SERVICETEKNOTES

TABLE OF CONTENTS

DC510/DC5010 INCORRECT COUNTING ABOVE 300 MHZ

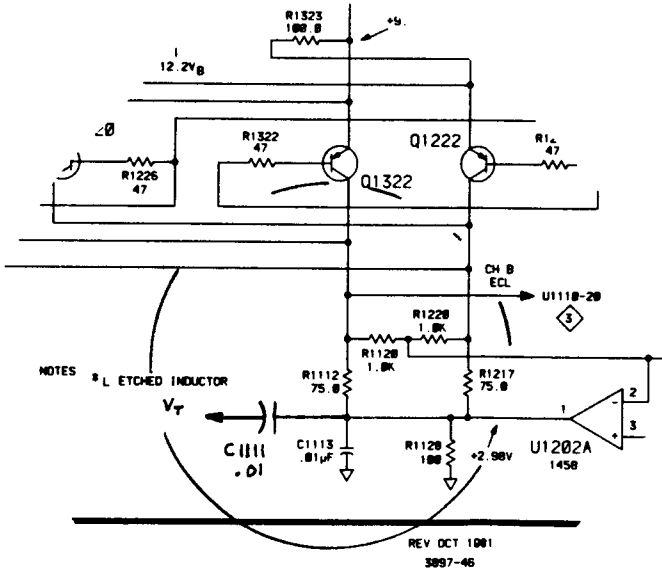
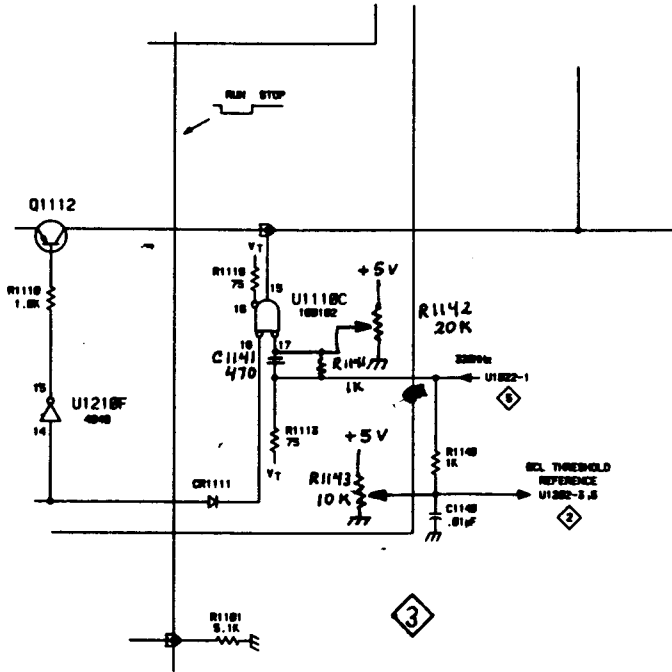
Problems with ECL IC's, P/N 156-1032-00, will cause the counters not to work properly above 300 MHz. A new part number, 156-1032-04 which is a Hitachi only i.c., has been

set up for U1001 and U1110. If U1001 or U1110 fails or the counter will not meet specifications and U1001 or U1110 is replaced, check that U1001 and U1110 are both the -04 part. This new part will ensure correct operation of the counter when both U1001 and U1110 are the -04 part. There must not be a mismatch of the -04 part combined with the -00 part.

The following changes must be made when adding the new parts:

1. Ensure U1110 pins 9 and 10 are shorted together and pins 21 and 22 are shorted together. Remove A12C1502.
2. Add A12C1111 P/N 283-0220-00 .01microfarad between A12R1112 and A12R1113 as shown on the diagram.
3. Add A12C1141 P/N 283-0315-00 in series with pin 17 of U1110.
4. Add A12R1141 P/N 317-0102-00 from the junction of pin 17 of U1110 and A12C1141 to R1113 as shown in the diagram.
5. Add A12R1142 P/N 311-0644-00 to U1110 with the wiper connected to pin 17 and the other leads connected one to the junction of pin 9 and 10, and the other lead connected to the junction of pin 21 and 22.
6. Add A12R1143 P/N 311-2102-00. The wiper lead connects to the empty hole next to the anode of CR1111 (see diagram) and connect the other two leads to C1114, one on each side.

DC510/DC5010 INCORRECT COUNTING ABOVE 300 MHZ (cont.)

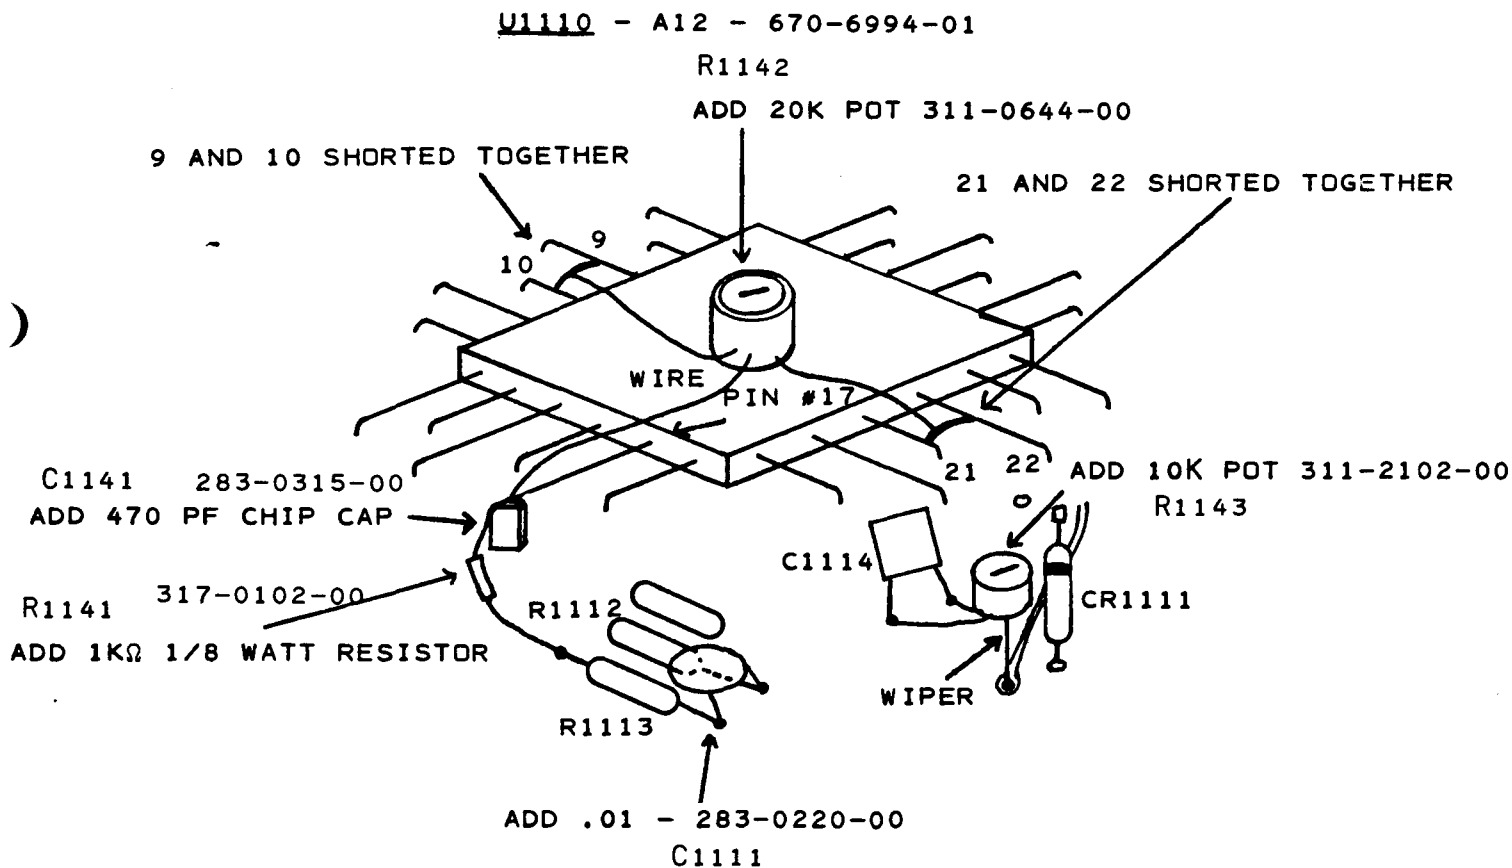
LIFT PIN #17 OF U1110 AND SOLDER 470 PF CHIP CAP (USING SILVER SOLDER) BETWEEN PIN #17 AND THE PAD ON THE BOARD.

690SR/6942 VIDEO AMP VMOS FETS

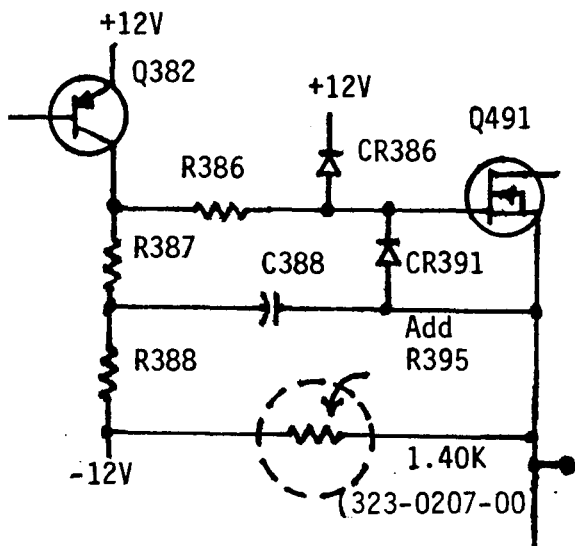
In order to get a better yield from some VMOS parts, they will be purchased with a 4.2 Vgs spec. The new part number for Q291, Q491 and Q691 will be 151-1143-01.

In order to have the circuit biased properly for these parts, a 1.4K Resistor (P/N 323-0207-00) needs to be added to each channel as shown in the figure below (Green channel shown).

A kit has been set up to accomplish this change when one of the affected transistors needs to be replaced. 050-1674-00 will supply one transistor to replace the failed part and three resistors to put into the circuit, one for each channel (Red, Green and Blue). Kit 050-1674-00 need only be ordered where a previous kit, 050-1582-00, has already been installed. Of course, once 050-1674-00 has been installed, you need order only the failed transistor replacement for that channel.
